**Proposal for:  
Supplement 10 to the 07 Series of Amendments,  
Supplement 02 to the 08 Series of Amendments and  
Supplement 03 to the 09 Series of Amendments  
of UN Regulation No. 14 (Safety-belt anchorages)**

This proposal is based on informal document GRSP-74-19 and the corresponding document GRSP/2023/28 and further amends the proposal originally introduced by OICA. Amendments to the text of UN Regulation 14 are indicated in bold or strike-through. Amendments to the text of GRSP/2023/28 are indicated in blue (according to GRSP-74-19).

During the last sessions of GRSP several CPs raised concerns and it was concluded to conduct a Workshop on this issue. The Workshop was held on 25th to 26th April at BAST and experts of Germany, the Netherlands, Sweden, Austria, OICA and CLEPA contributed. Further modifications to GRSP-74-19 are indicated in green.

**Figure 3**

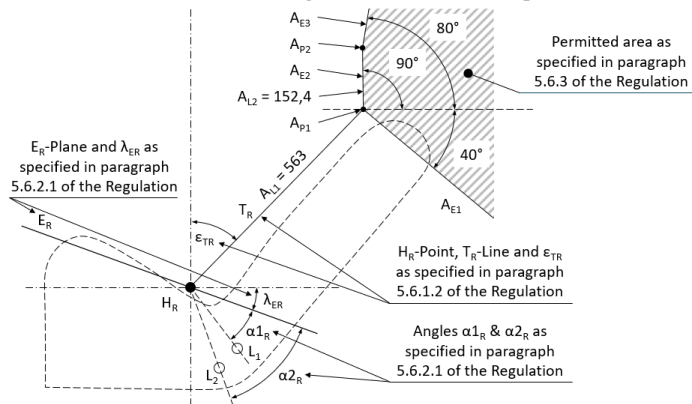
**Areas of location of effective belt anchorages according to paragraph 5.6.2 and 5.6.3 of this Regulation for extended use positions**

**Figure 4**

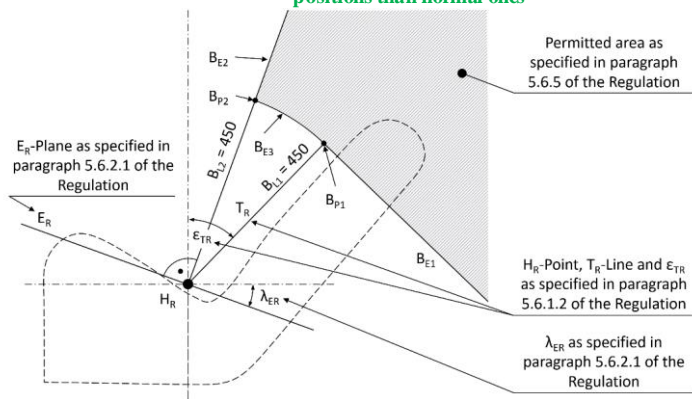
**Kommentiert [AP6]:** Figure needs to be amended at least for 152 mm after the follow-up meeting

**Permitted area of location for upper effective belt anchorages according to paragraph 5.6.5 of this Regulation for extended use positions other use positions than normal ones**
